WATER QUALITY MEMORANDUM

Utah Coal Regulatory Program

SUBJECT: Fourth Quarter of 2013 Water Monitoring, Andalex Resources, Centennial Mine, C/007/0019, Task ID #4468

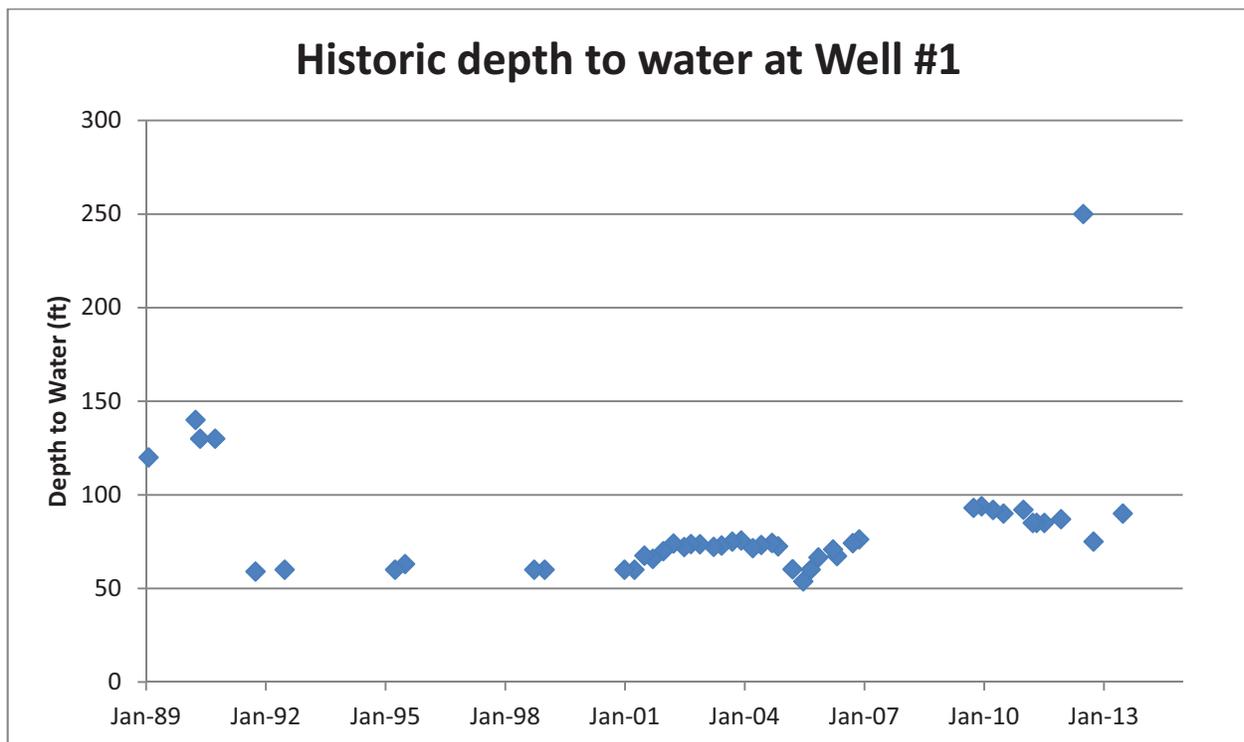
The last depth to water level measured 90 feet, which appears to be consistent with data from previous year's seasonal data. The 250 reading from Second Quarter of 2012 appears to have been an erroneous measurement. The well was not measure during Third Quarter of 2013.

The continued examination of the depth to water at Well #1 is required.
